Y.K Knitwear Ltd. #10331

Plot S-7 & S-8, Estate Kanabari, Gazipur Sadar

05.May.2014

Identified Priority 1 Concerns

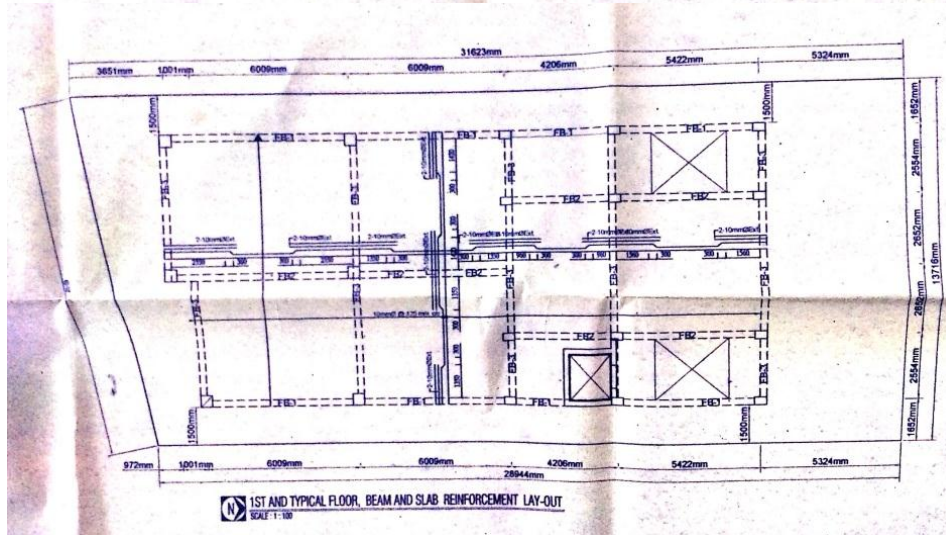
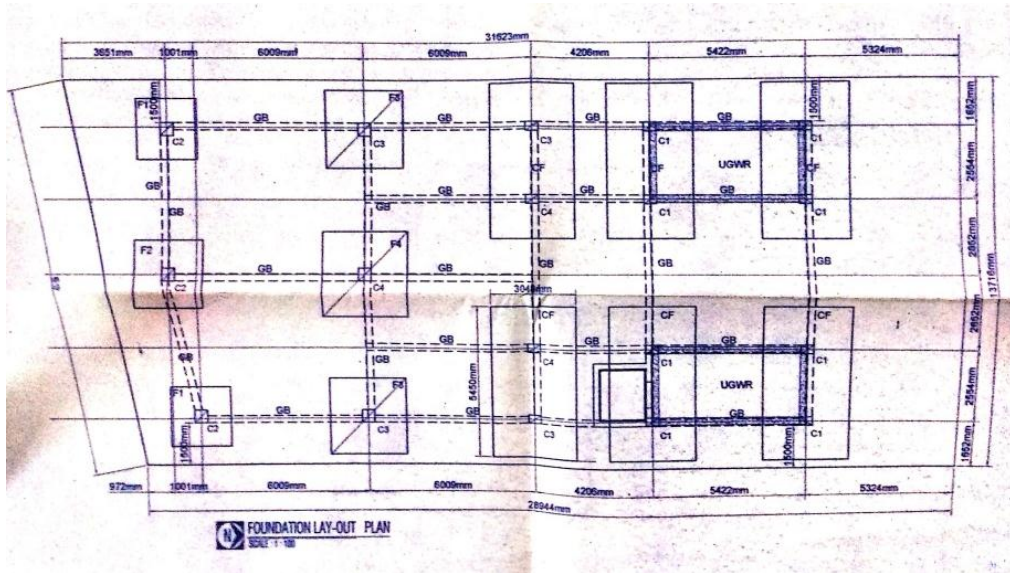
The current loading plan evaluates the total load on the total floor area. A proper loading plan is required for every floor which splits the loading into tributary areas associated columns.

Furthermore, heavy loading was found on the cantilever section at the joint on the storage floor. Managing Director and Factory Engineer were advised to reduce loading on cantilevered section

Reduce loading to 3 kPa until capacity assessment is made.

Partial plan view - column layout

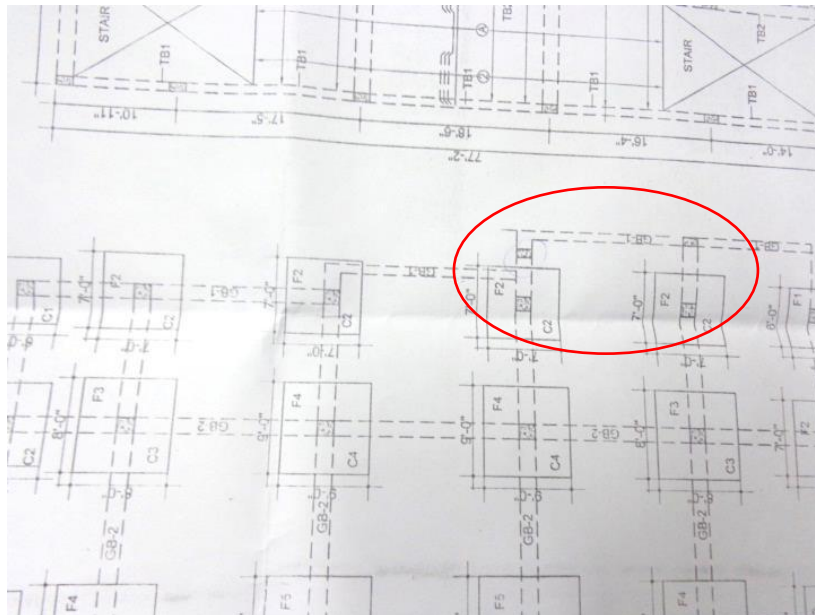
In the 6 storey section, there is small section at the back where there is a small column that runs down to a cantilevered grade beam. The column is not in the schedule and the rebar for the grade beam seems low as it shows only 5 top bars.

This area needs to be verified in a Detailed Engineering Assessment
